Access Compliance Report

Public Rights-of-Way

Intersection ID: 29486	Main Street: WILORA_LAKE_RD	Cross Street: WILORA_LANDING_RD	Location: NE
ADA ID: F0C15A496226	Ramp Type: PerpDiag	Initial Pass/Fail: Fail	Overall Compliance: No
		Severity Score: 22.5

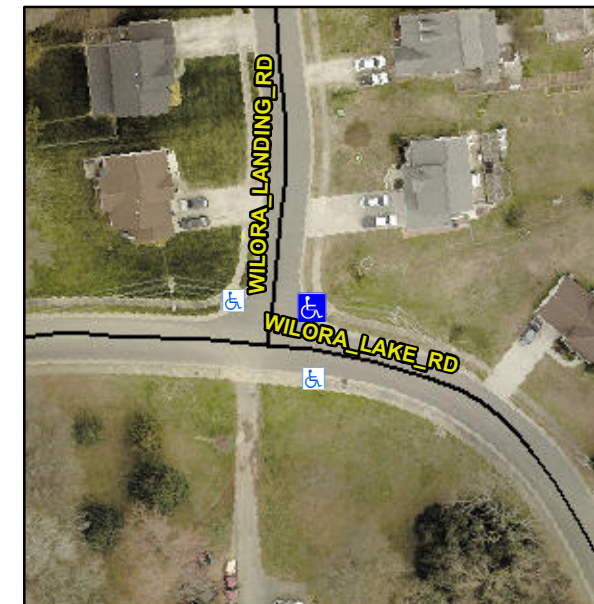
Not Found, R304.5.1, R304.2.2, R304.5.3

Compliance	Description	Data	Compliance	Description	Data
N/A	Ramp Length (in)	48.0	No	Ramp Slope (%)	10.2
No	Ramp Width (in)	46.5	No	Ramp XSlope (%)	2.2
N/A	Flare Type LT	N/A	N/A	Flare Type RT	N/A
N/A	Flare Slope LT (%)	N/A	N/A	Flare Slope RT (%)	N/A
N/A	Flare Traversable LT?	N/A	N/A	Flare Traversable RT?	N/A
N/A	Landing Length (in)	N/A	N/A	DWS Provided?	N/A
N/A	Landing Width (in)	N/A	N/A	DWS Contrast?	N/A
N/A	Landing Slope (%)	N/A	N/A	DWS Length (in)	N/A
N/A	Landing X Slope (%)	N/A	N/A	DWS Full Width?	N/A
N/A	Landing Curb? (Y/N)	N/A	N/A	DWS Offset (in)	N/A
N/A	Shared Landing?	N/A			
N/A	Gutter Ponding?	N/A	N/A	Gutter Slope (%)	N/A
N/A	Gutter Lip Ht (in)	N/A	N/A	Gutter X Slope (%)	N/A
N/A	Painted X Walk1?	No	N/A	Painted X Walk2?	No
	X Walk 1 Direction	To W		X Walk 2 Direction	To S
N/A	X Walk 1 Width (in)	N/A	N/A	X Walk 2 Width (in)	N/A
	X Walk 1 Slope (%)	0.6		X Walk 2 Slope (%)	1.2
	X Walk 1 X Slope (%)	3.5		X Walk 2 X Slope (%)	2.7

Remove & Replace Curb Ramp With Two New Directional Ramps or Equivalent.
